HELICOPTERS DIVISION

TECHNICAL INFORMATION LETTER

TIL N° T-109-24-002 T-109SP-24-004

SUBJECT: Tail rotor duplex bearing support improvement

Figure 1 – Duplex bearing retaining system – Current design

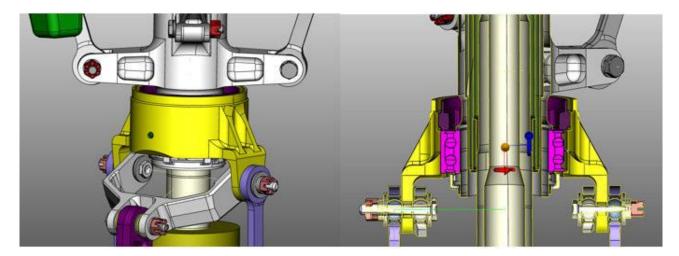
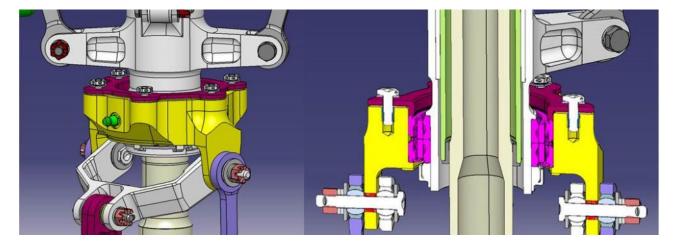
These SBs will provide the necessary instructions to introduce on the A109/AW109 in service fleet the new retaining system of the duplex bearing consisting of a new sleeve assembly support and a new bearing support flange which is retained to the housing with six (6) bolts (Ref. to Annex A pictures).

The following figures show how the retaining system changes with the implementation of the present improvement: the retaining nut is replaced with a plug which is locked with multiple bolts.
